# FINAL PLAT

## REED'S COVE ADDITION

RE: SUB 2002-57- Final Plat of Reed's Cove Addition

**STAFF REPORT**

DETAIL - RESERVE "H"

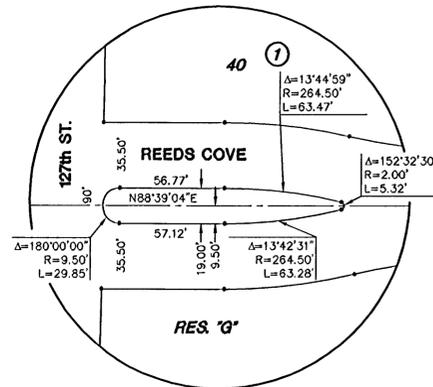
- H. Traffic Engineering has requested the deletion of Reserve H located at the entrance to the Addition along 127th St. East. *The applicant has reduced the size of Reserve H which is acceptable to Traffic Engineering.*
